Municipal Office,
Karachi, 19th August 1918.

With reference to his application dated 29th July 1918 with plans of the proposed rooms and shed to be erected on plot No. 5.K-3 Lyari Quarter Mr. Ladha Khimji is informed that there is no road to the North of the plot, it is Municipal saleable land. The area marked thus must be kept open to sky and a window provided as shown in the room on the South West of the plot.

NOTICE UNDER SECTION 96 OF ACT III OF 1901.

Plan showing proposed shed to be built
on Plot No 5 Sheet No 3 Lyarce Quarter
Scale 5-1

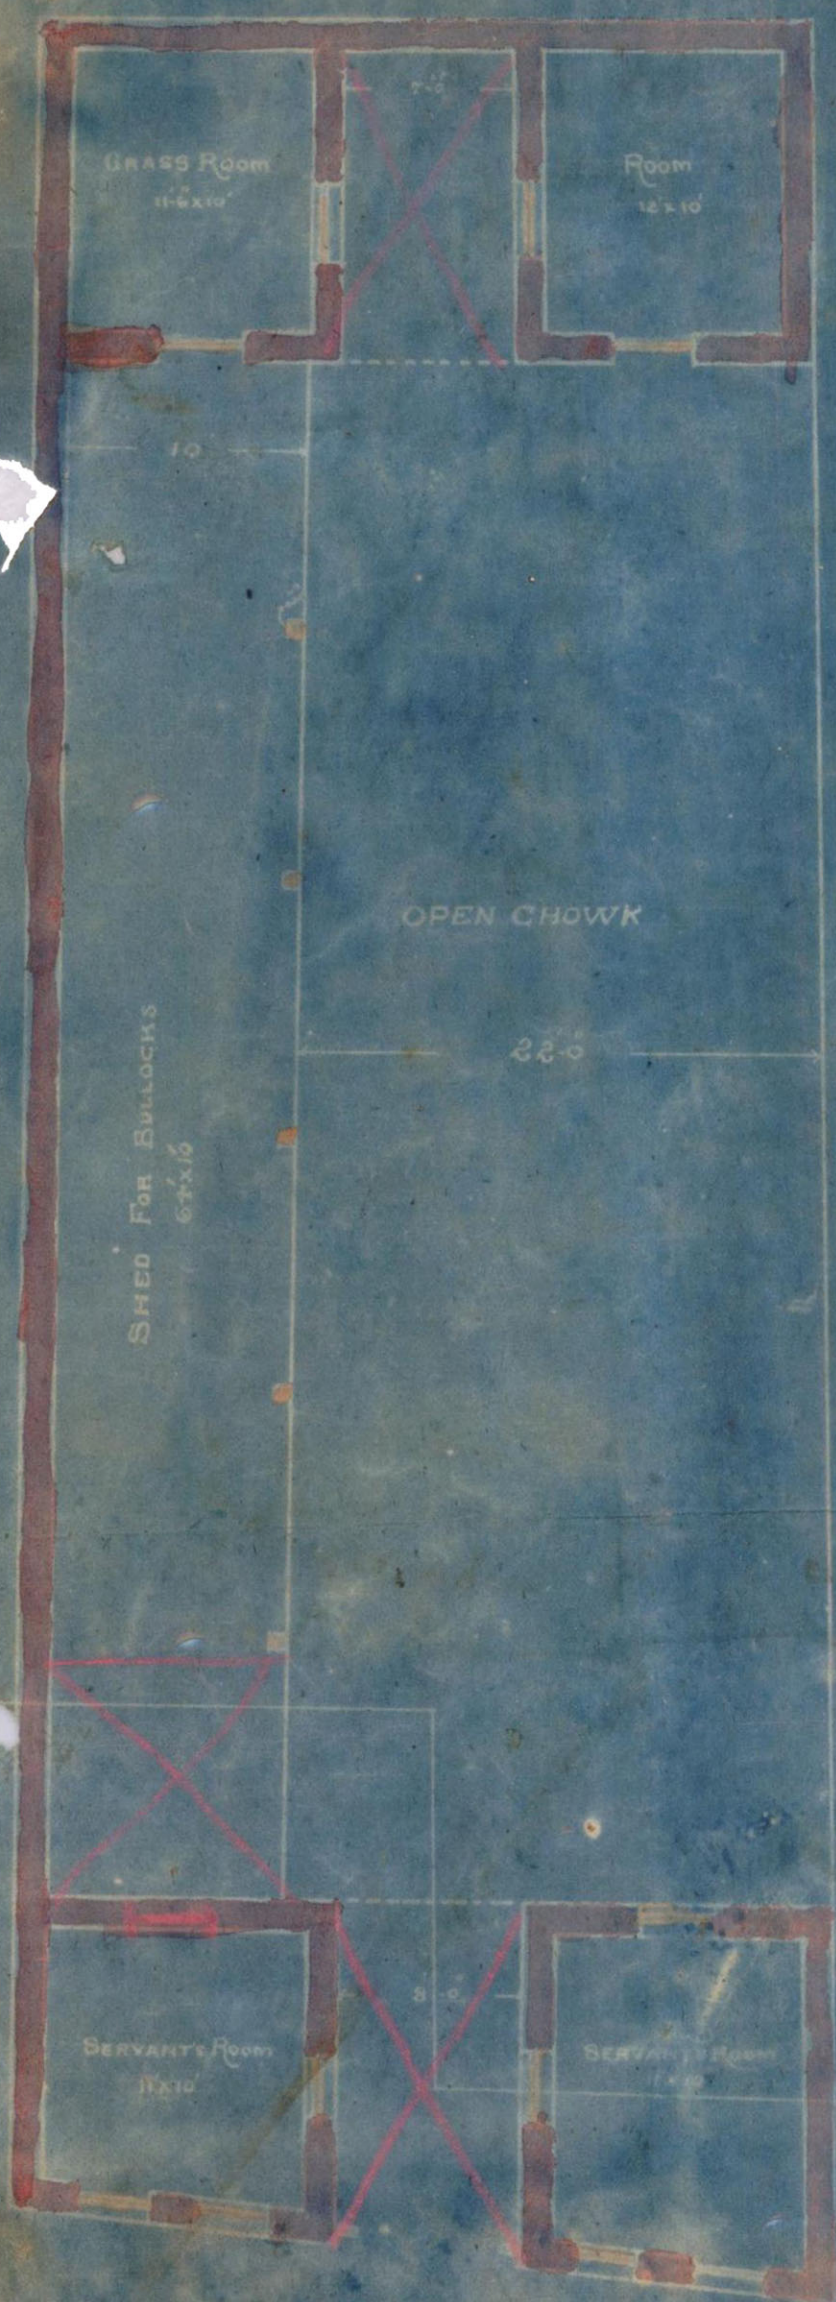
If there is a road to the north
of the plot, very the rooms are not
provided with windows for in them all
facing this road & here the windows
are provided in rooms which are built
on the very narrow plot.

They request that the space ^{7-0 inch} between the two rooms
on north side should be kept open to keep
the rooms airy + in light - Requested

Remarks Sir, With reference to this I have before that
there seems no objection provided the rooms
towards north & south take kept open to sky
then there seems no objection
Y. D. V. S. Khan

There is no road to the north of the plot it is
high valuable land. The area marked there
must be kept open to sky & a window
provided as shown in the room of the
South West of the plot
